FINAL
Stream and Wetland Mitigation Plan
St. Clair Creek Restoration Project
Beaufort County, North Carolina

EEP Project ID No. 95015

20.0	APPENDIX F – HEADWATER REFERENCE INFORMATION.....	20-1
21.0	APPENDIX G – JURISDICTIONAL WETLAND DETERMINATION.....	21-1
22.0	APPENDIX H – RESPONSE TO EEP COMMENTS ON DRAFT MITIGATION PLAN	22-1

23.0	APPENDIX I – NCIRT COMMENTS ON FINAL DRAFT MITIGATION PLAN AND RESPONSE .	23-1
24.0	APPENDIX J – NCIRT FINAL APPROVAL LETTER	24-1

2.4 Watershed Map

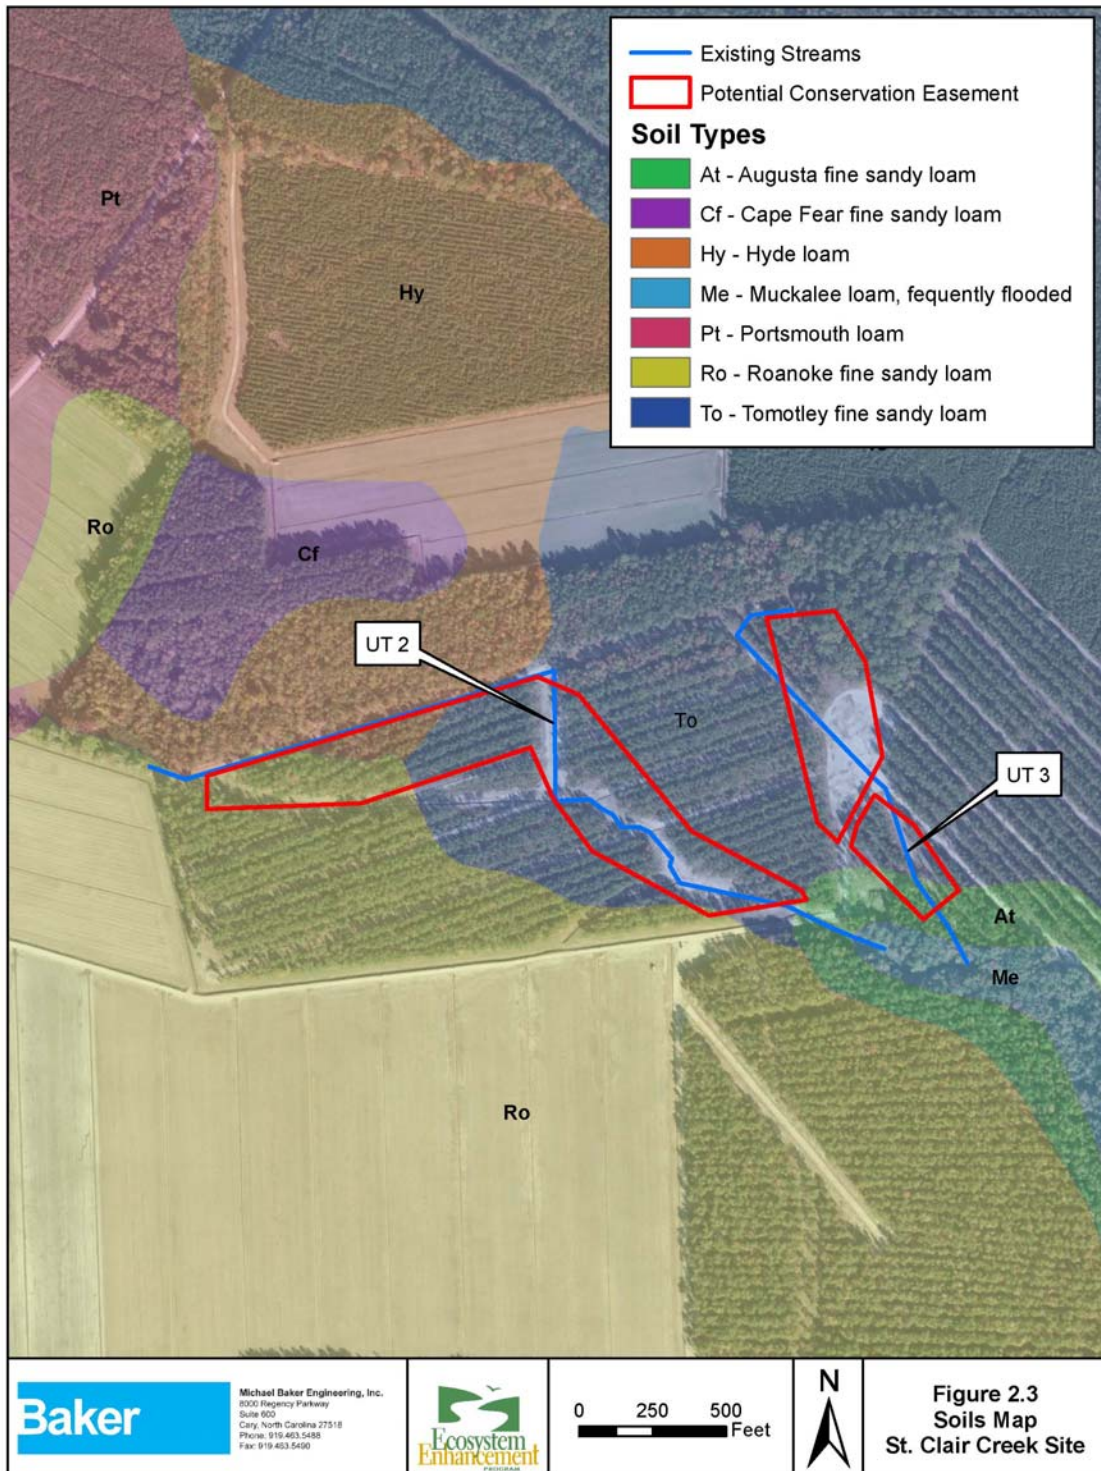
- **FYI looking at Figure 2.2, it was unclear why the watershed delineation of UT2 ended at Peoples Road. I calculated the watershed sizes using the USGS streamstats website, and they may be larger than reported. Streamstats calculated 358 acres for UT2 and 43 acres for UT3, so they may be larger than reported. Also, WaRO personnel confirmed fairly well-defined valleys (for Beaufort County) on the site.**

2.5 Soils Map

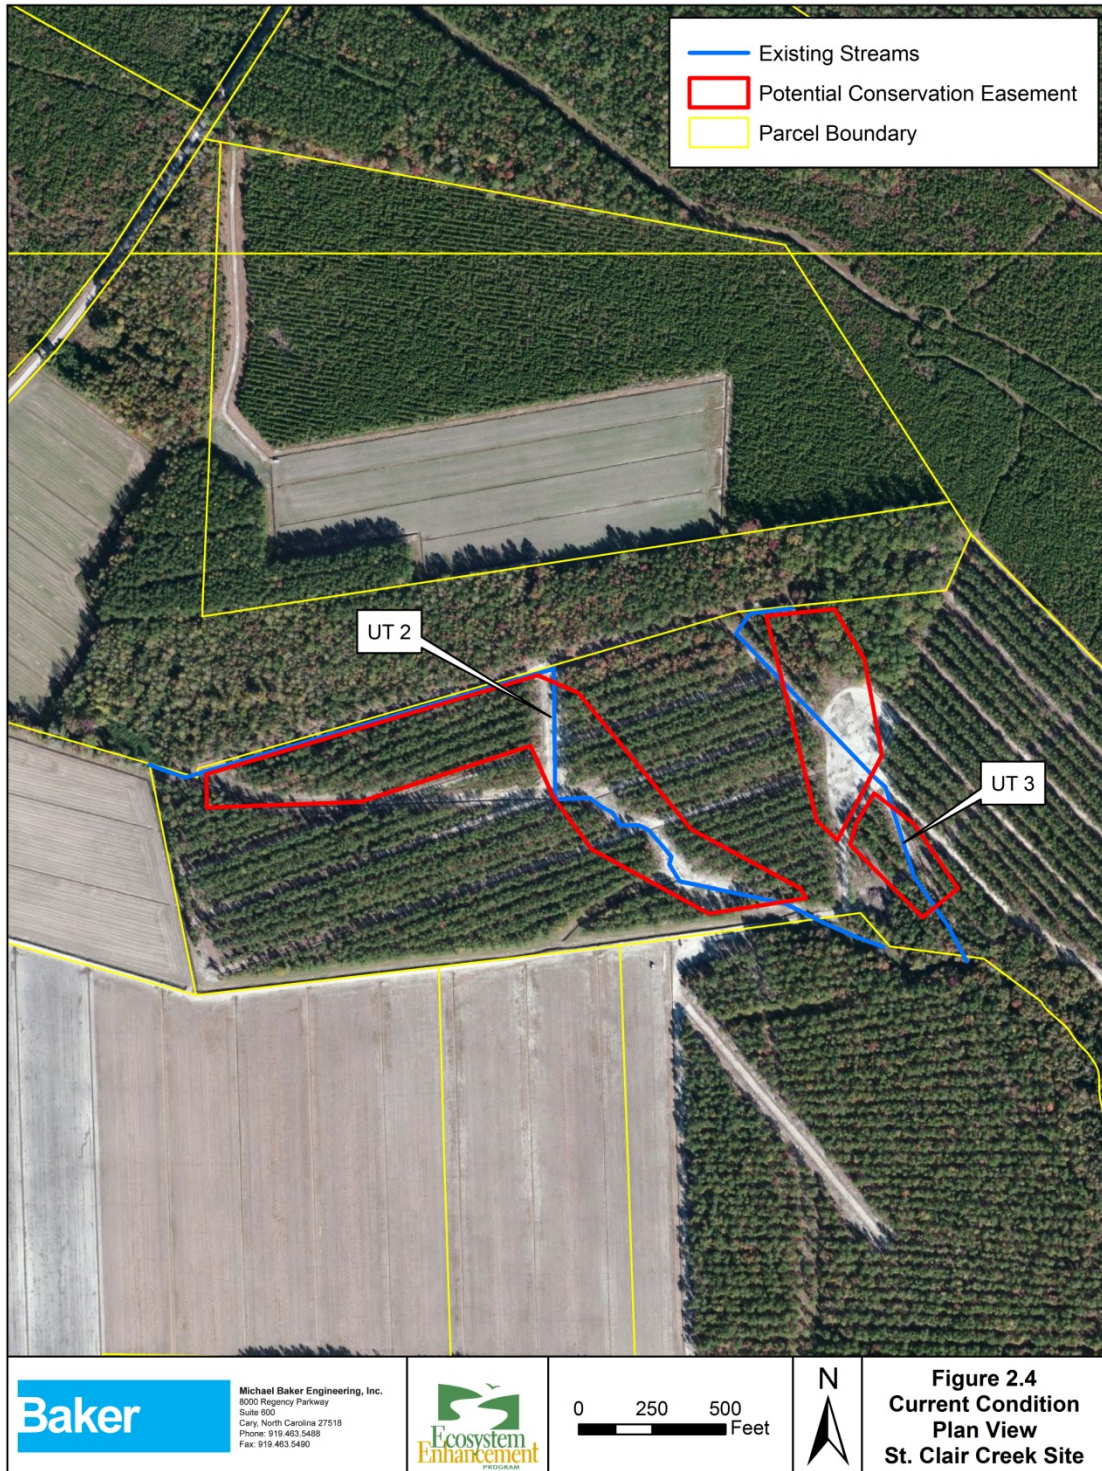
9. Figure 2.5: Adjust figure so soil map abbreviation appears for the areas with UT3 and portions of UT2

Response: Adjusted Figure 2.5 to lower the abbreviation for Tomotley fine sandy loam (To) from underneath the legend.

BAKER PROJECT REFERENCE NO. 125116	SHEET NO. 6
PROJECT ENGINEER	
PRELIMINARY PLANS DO NOT USE FOR CONSTRUCTION	
Baker	
<small>Michael Baker Engineering Inc. 6000 Regency Parkway, Suite 600 Cary, NORTH CAROLINA 27518 Phone: 919.453.5493 Fax: 919.453.5490 License #: F-1084</small>

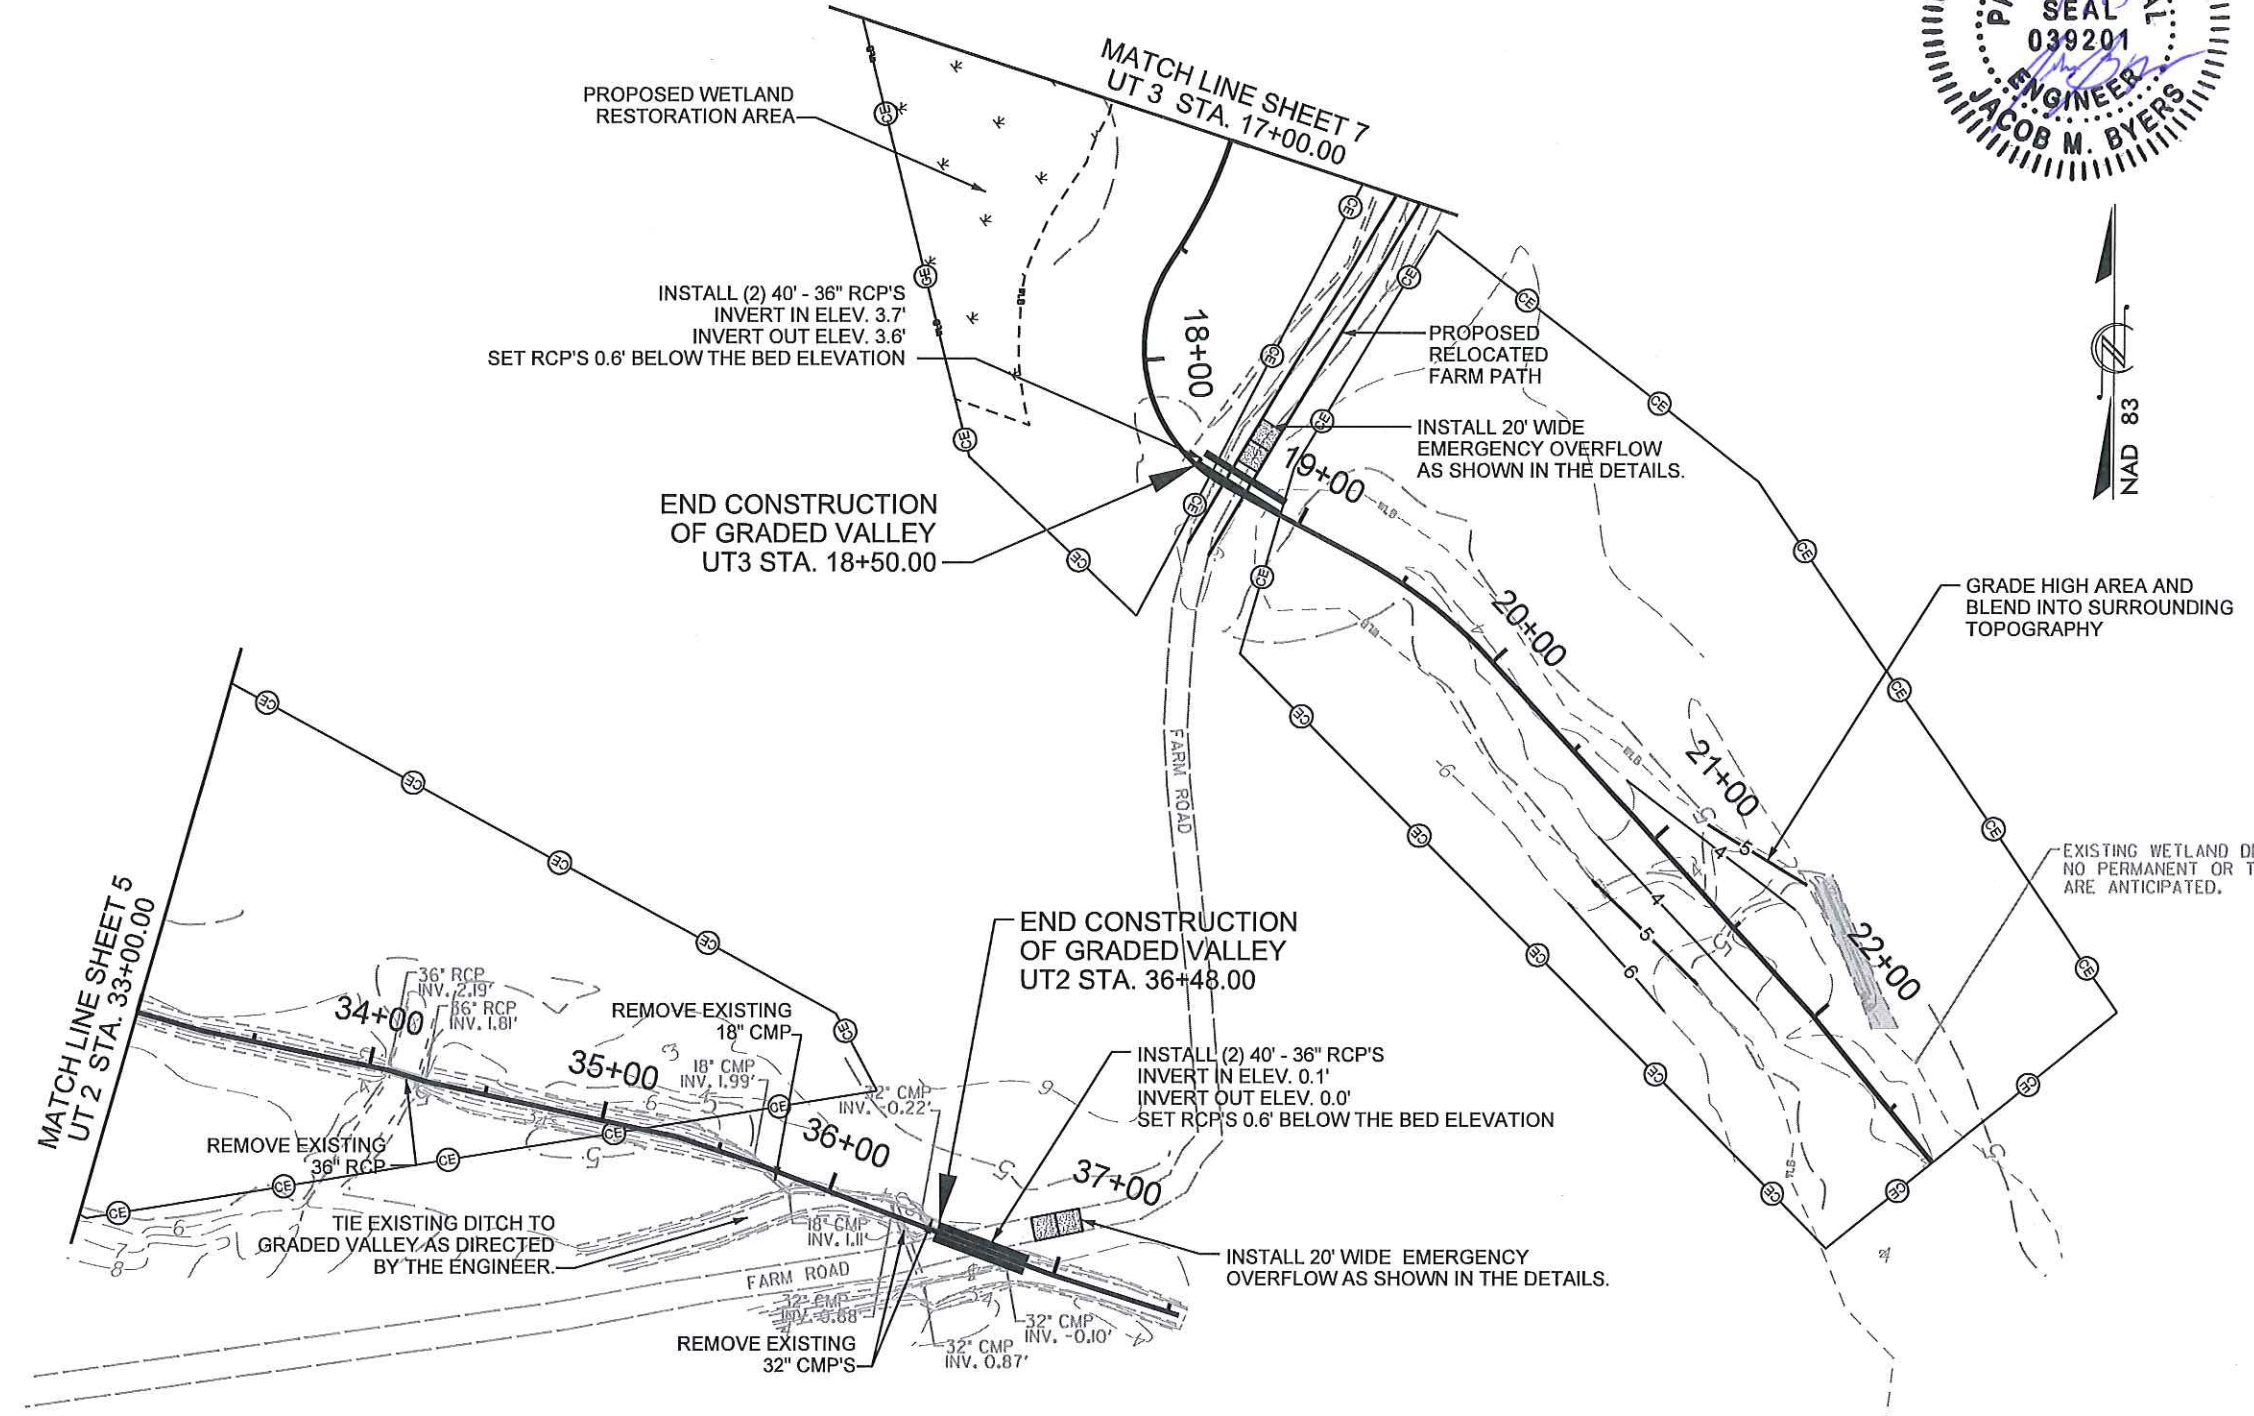
22. Sheet 6- Explain grading outside of conservation easement.
